IE Inspection Report No. 050-263/75-16

Monticello Nuclear Generating Plant
Monticello, Minnesota

IE Inquiry Report No. 050-263/75-01Q (CDR)

Rework and Repairs - Feedwater Nozzles and Sparger Units

Figure 1

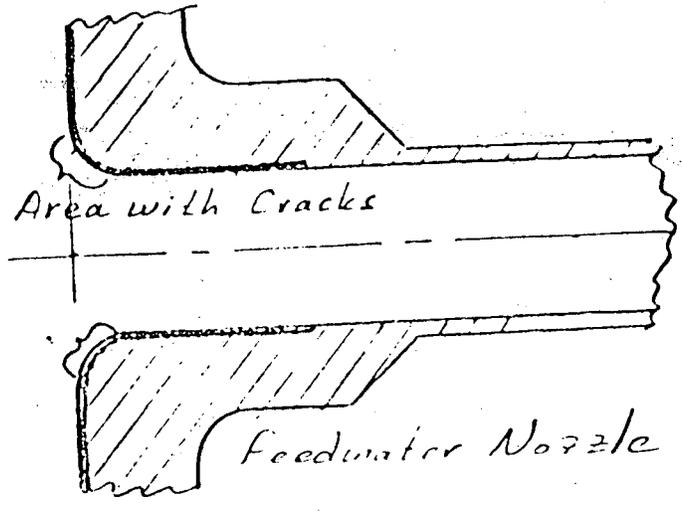
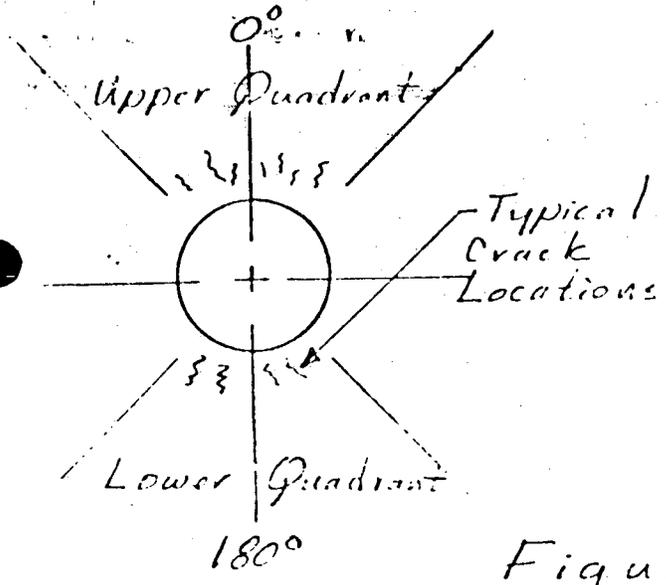
Approximately 200 crack indications have been found on the inside of the vessel where the four horizontal ten-inch feedwater nozzles merge into the vertical wall of the reactor vessel. The indications were generally concentrated in the upper and lower quadrants as shown on the attached drawing (figure 1). The locations of the cracks as marked by crayon for grinding are shown on the photograph of the 60° nozzle (figure 2). The vertical axis is represented by the 0-180° line. All four nozzles had some indications, but the nozzle at 60° appeared to show more indications. The indications were parallel or nearly parallel to the axis of the pipe as shown on the photograph with penetrant applied, of the 60° nozzle at 330° orientation (figure 3).
